**NOTICE OF MEETING  
SEPTEMBER 10, 2025 – 6:00 PM  
PLAN COMMISSION  
TENTATIVE AGENDA**

**PRELIMINARY PLAT  
REVIEW – Westborough  
Country Club, 720 W.  
Lockwood Ave.**

# WESTBOROUGH COUNTRY CLUB PRELIMINARY PLAT

RE: Westborough Country Club Preliminary Plat Consolidation Review  
631 South Berry Road, Glendale, Missouri 63122

PRELIMINARY PLAT  
SOUTHWEST SITE

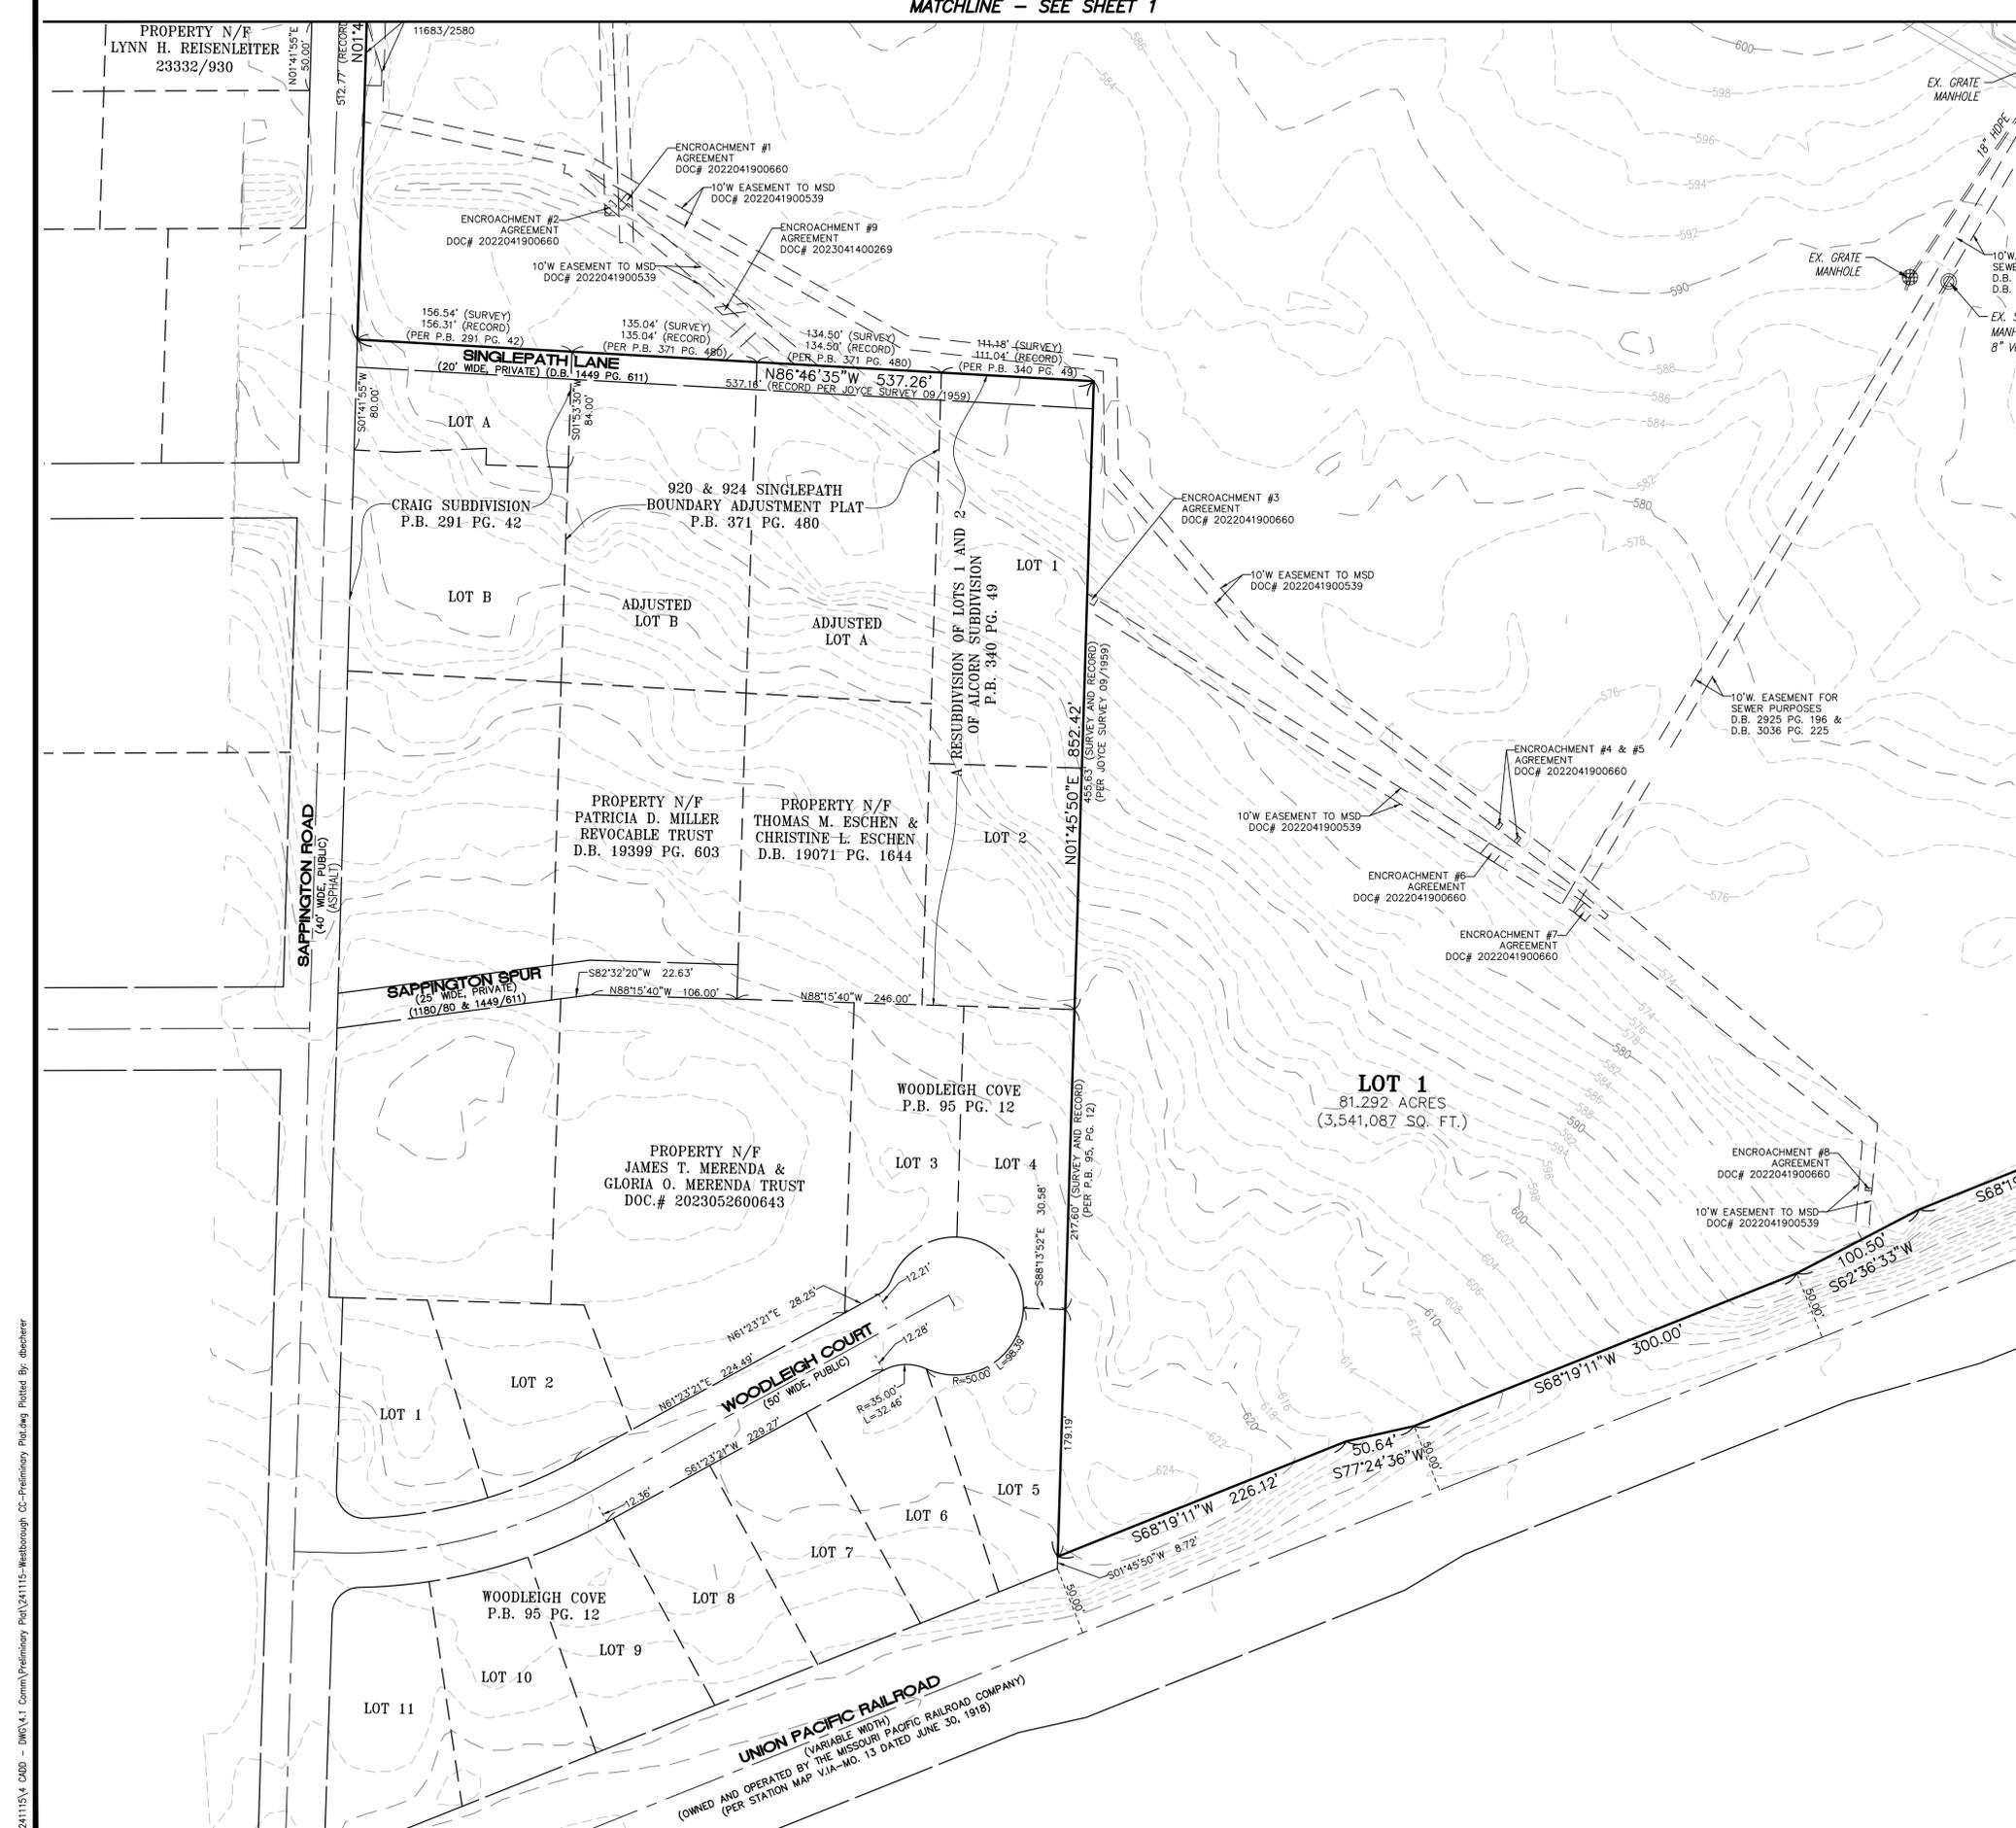
The existing lot lines, easements, and rights-of-way are correctly identified and labeled. In addition, the survey ties into the cities of Glendale's and Oakland's coordinate system and benchmark data where applicable.

It is determined that adequate public right-of-way is provided per the City of Glendale and St. Louis County standards. Existing access points to public streets are clearly shown and dimensioned. Also, existing utility easements (public and private) are shown and labeled in the preliminary subdivision plat.

The existing stormwater drainage facilities and stormwater easements are reflected on the preliminary plat.

The consolidated lot complies with minimum lot area, frontage, and setback requirements of the current zoning designation.

1. The applicant shall ensure closure reports for new lot boundaries are submitted and meet platting standards. Revisions to the preliminary plat are not required.

2. The applicant shall ensure that if a new access is proposed, it may require separate permit reviews under applicable access management guidelines. Revisions to the preliminary plat are not required.

3. Any conflicts between utility easements and proposed building areas must be resolved prior to final plat approval. Revisions to the preliminary plat are not required.

4. The applicant shall ensure dedication of utility easements along each frontage or location as required for future service. Revisions to the preliminary plat are not required.

5. A stormwater drainage management approach may be required depending on the scope of the future development. Revisions to the preliminary plat are not required.

6. The applicant shall ensure that no existing drainage patterns are adversely impacted by the consolidation. Revisions to the preliminary plat are not required.

7. It is recommended that the applicant coordinate with the Planning Department to address any resulting nonconformities. Revisions to the preliminary plat are not required.

The City Engineer has no objection to the preliminary plat consolidation moving forward, subject to resolution of the above comments prior to final plat approval.
